MODIFICATION SHEET NO.RDSO/2008/EL/MS/0372 (REV.0), DATED 20.01.2009

Modifications in Auxiliary Converter of 3-Phase Electric locomotive to improve reliability.

1. EXISTING ARRANGEMENT

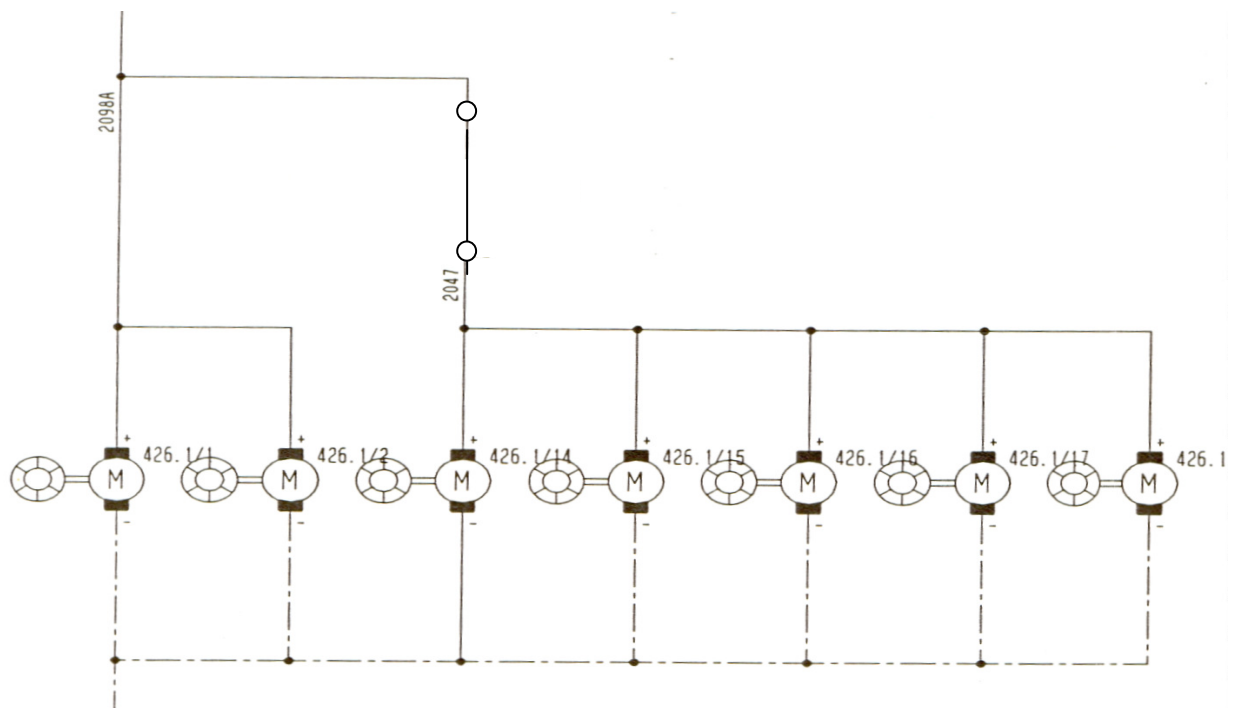
- i) Gate unit cover of WRE module as per drawing no. HIET200196 (Adaptation –1).
- ii) BUR electronics rack cover (top & bottom) as per drawing no.3EHE400523 (Adaptation –1)
- iii) The thermostat is shorted to make the cooling fans continuously 'ON' as per Annexure- 'A'.

2. MODIFIED ARRANGEMENT
